SERVICE BULLETIN SB271107

ICON CONTAINER GROMMET INSPECTION Issue Date : November 27. 2007

Status : Precautionary

Pictures:

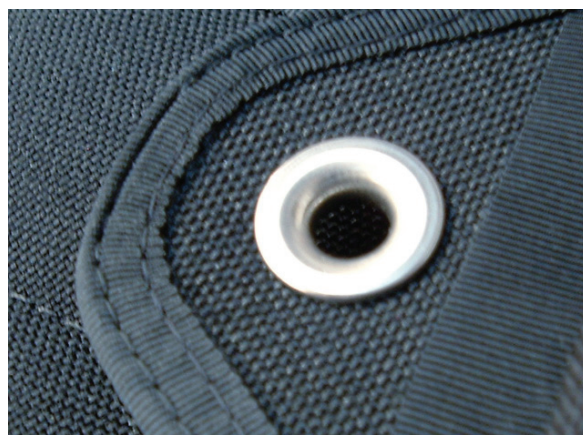
The Damage can be seen on the inside of the Grommet where the Closing Tool has scratched the Inside Surface of the Grommet. The seating of the Grommet needs to be inspected to ensure correct and flush seating of the Grommet.

1. Damaged Grommet
see damage on inner ring of grommet

1. Undamaged Grommet

This could well be an isolated incident, but as a matter of precaution Aerodyne is recommending all Grommets on the ICONs listed in the Identification paragraph above be Inspected.
